PD Modification Application: PRS 26-0173**Zoning Hearing Master Date:** N/A**BOCC Land Use Meeting Date:** July 21, 2026**Hillsborough
County Florida****Development Services Department****1.0 APPLICATION SUMMARY****Applicant:** Mark Bentley, Esq., B.C.S., AICP**FLU Category:** CMU-12**Service Area:** Urban**Site Acreage:** 9.86**Community
Plan Area:** Riverview**Overlay:** None**Introduction Summary:**

The applicant is requesting a minor modification to reduce the 2:1 height requirement to a 1:1 height requirement. The applicant is also asking for variation to the hotel parking requirement from 1.1 spaces per guest room to 1.0 space per guest room. In addition, the applicant is proposing an increase building setback to the east property line from 30 feet to 40 feet.

8.2 Proposed Site Plan (Full) (Sheet 1)

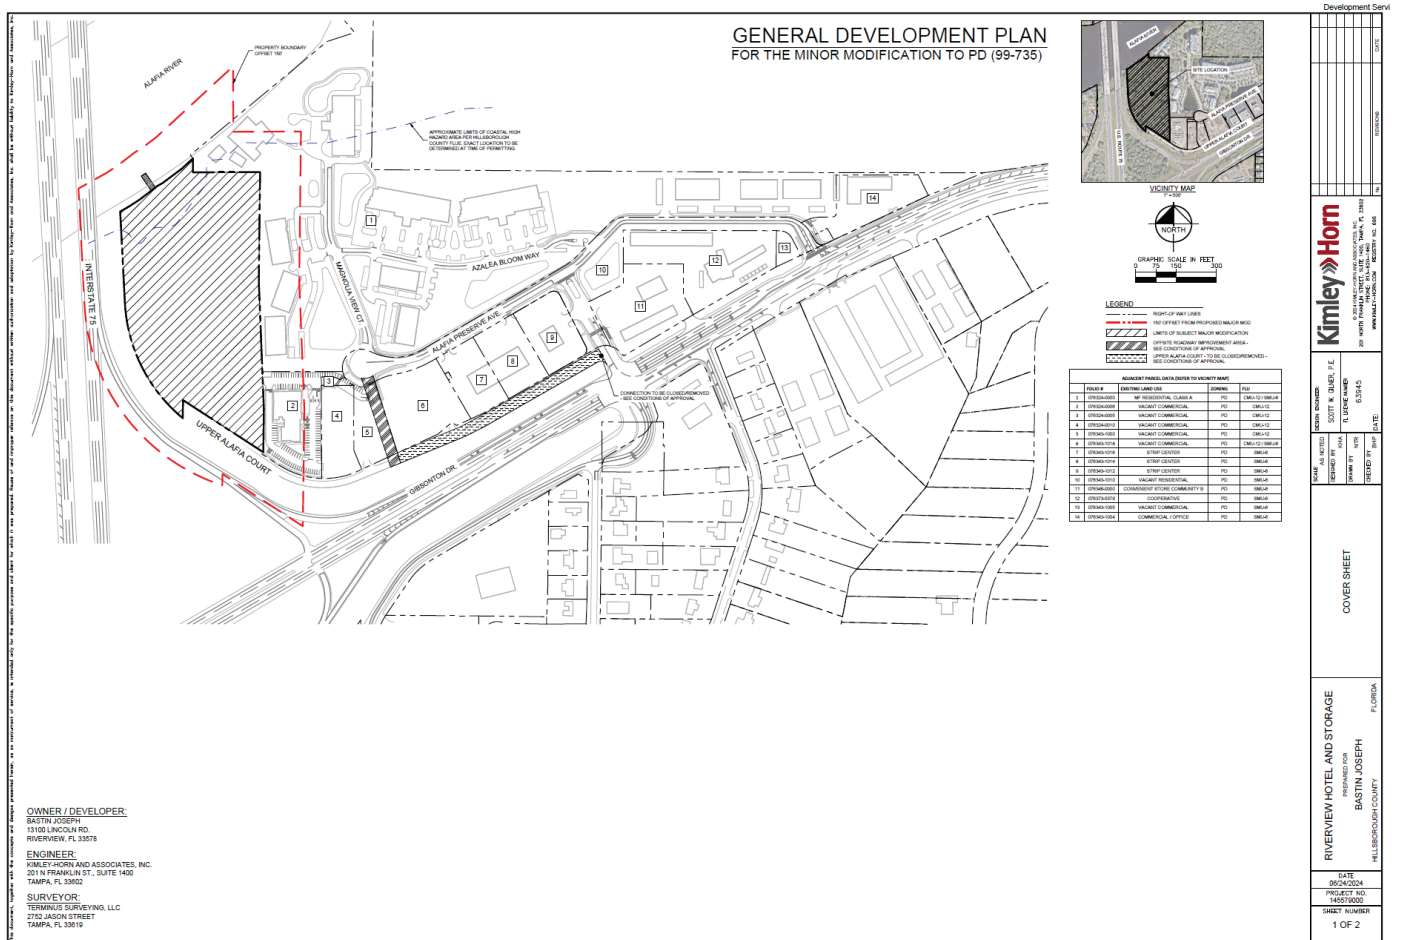
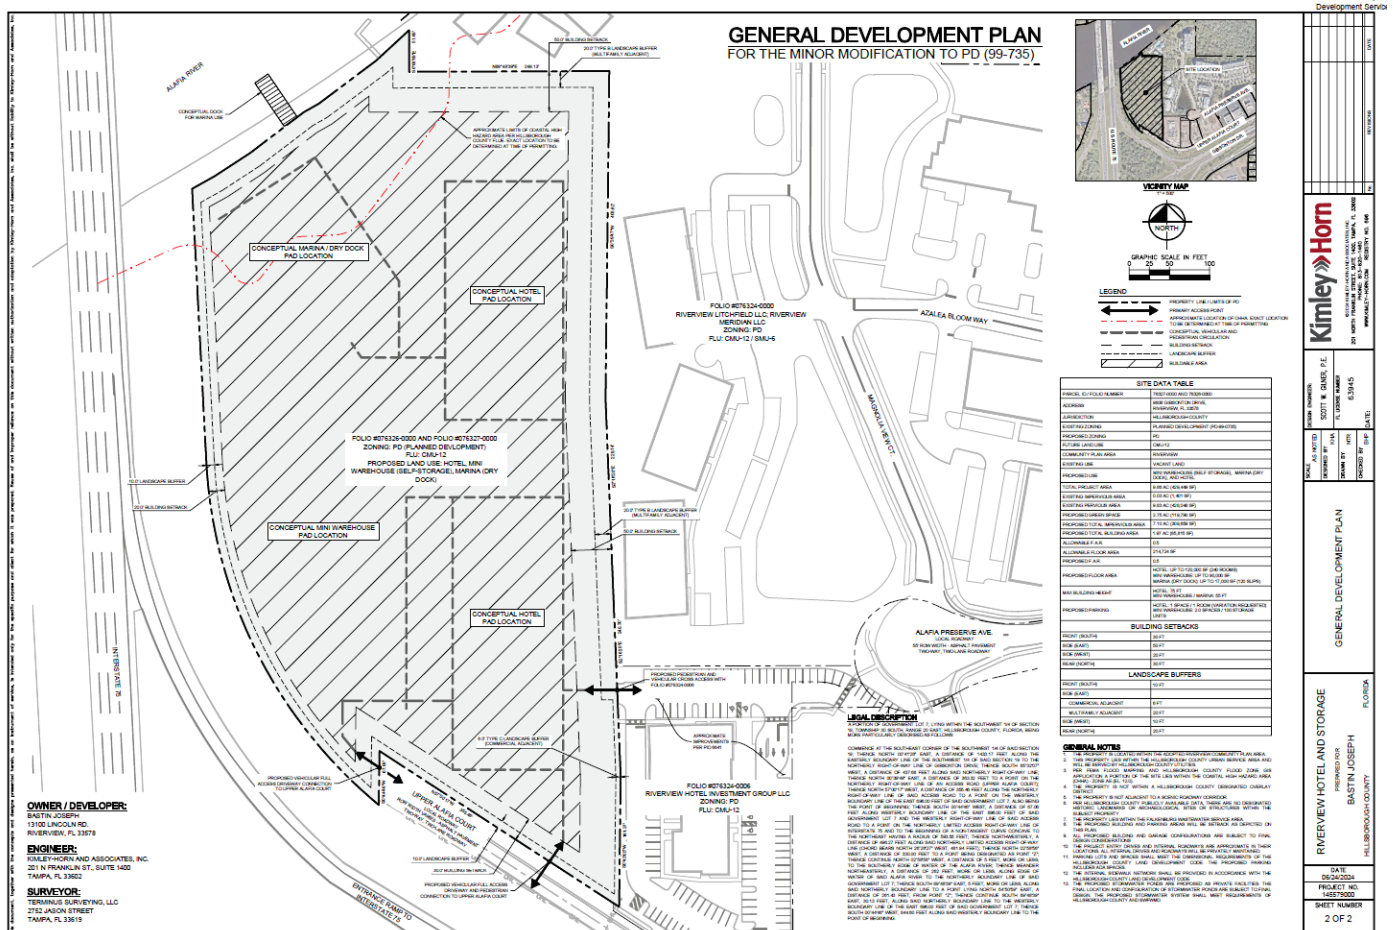
The applicant seeks to modify Planned Development 99-0735 in order to amend the 2:1 setback requirement to a 1:1 setback for the hotel use. In addition, the applicant has requested a parking variance to allow 1.0 space per guest room, rather than the 1.1 space per guest room.

To address staff's concerns with the 2:1 setback requirement change, the applicant has proposed an increase to the east side yard setback to a minimum of 40 feet, an increase of 10 feet from the previous approval. The additional setback under the 2:1 requirement is 110 feet, with a 30-foot setback, resulting in a setback of 140 feet (inclusive of the 20-foot-wide buffer). The additional setback under the 1:1 requirement is 55 feet, with a 40-foot setback, which results in a setback of 95 feet (inclusive of the 20-foot-wide buffer). Under the existing, a 20-foot high building has a minimum setback of 30 feet. Under the proposed, a 20-foot high building has a minimum setback of 40 feet. Property to the east is developed with multi-family structures at heights of 2 to 5 stories in height, which are not subject to the 2:1 setback.

Alafia Preserve Ave and Fern Hill, request for ownership transfer (Inspection Report)
Section 19, Township 30, Range 20 East
Folio: 076343-1010
Hillsborough County, Florida
Plat Book; NA

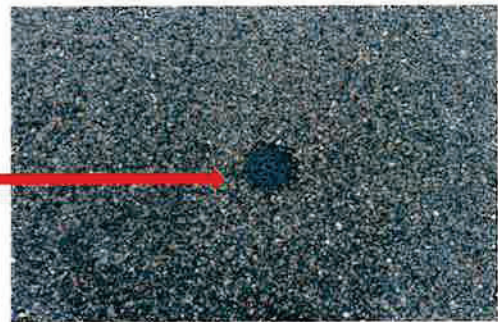
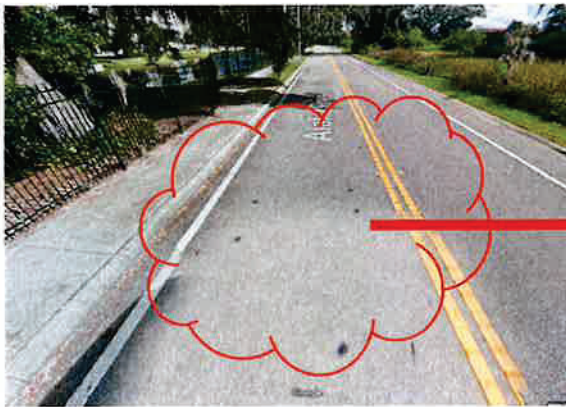
8. There is a depression around station 15+00, on the area covered by pavers (trip hazard).
It should be noticed that Hillsborough County does not favor pavers on public sidewalks.

9. Stop bar missing at the Northeast side of Alafia Preserve Ave. and Fern Hill Dr. the interception.

Fern Hill Drive

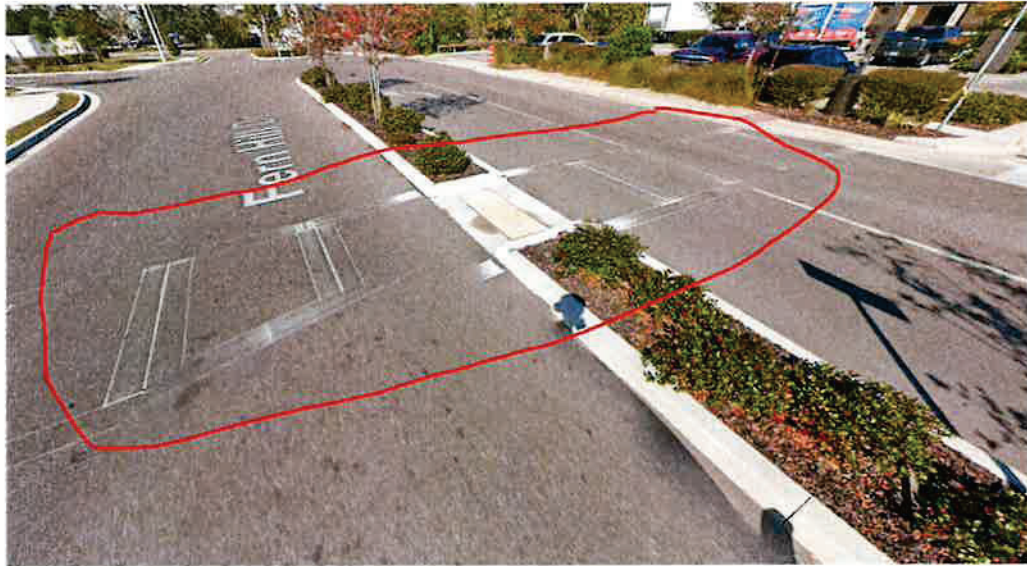
14- Missing Striping for bike lane at Alafia Preserve Ave.

Alafia Preserve Ave and Fern Hill, request for ownership transfer (Inspection Report)
Section 19, Township 30, Range 20 East
Folio: 076343-1010
Hillsborough County, Florida
Plat Book; NA

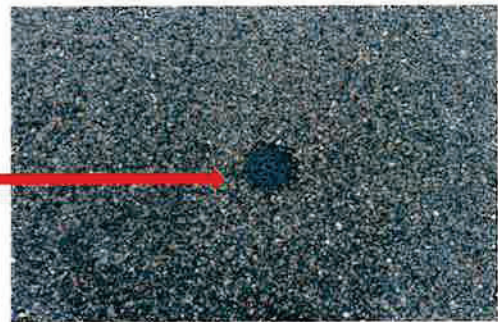
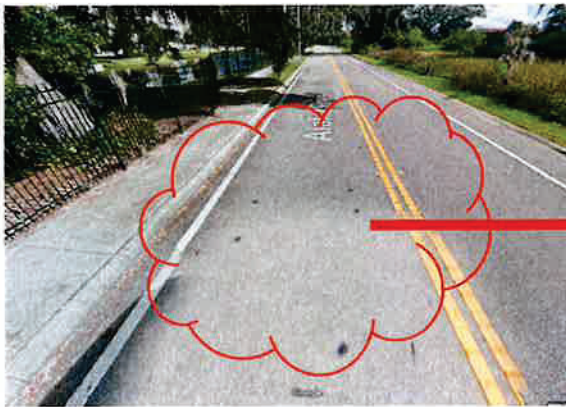
8. There is a depression around station15+00, on the area covered by pavers (trip hazard).
It should be noticed that Hillsborough County does not favor pavers on public sidewalks.

9. Stop bar missing at the Northeast side of Alafia Preserve Ave. and Fern Hill Dr. the interception.

Fern Hill Drive

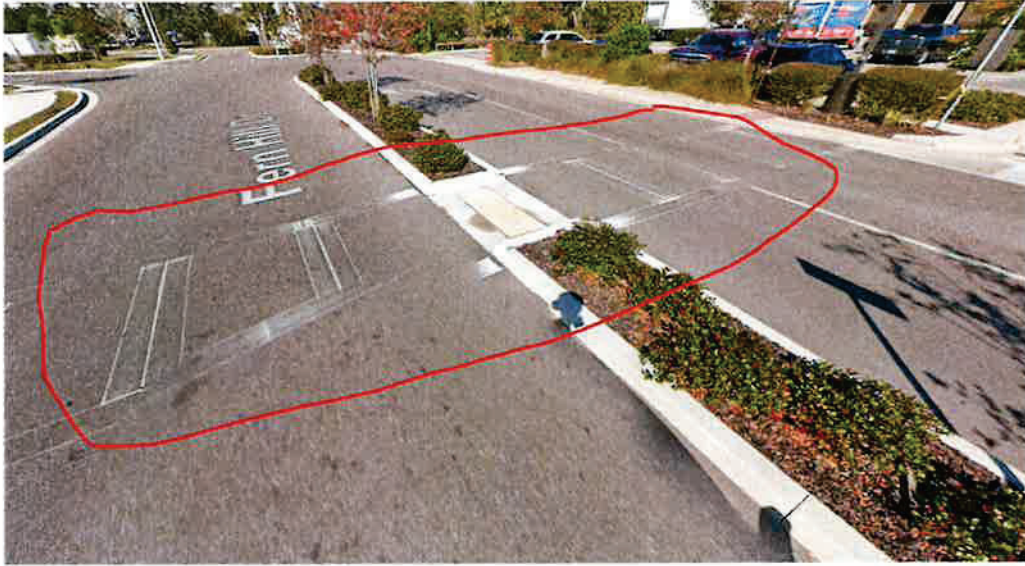
14- Missing Striping for bike lane at Alafia Preserve Ave.
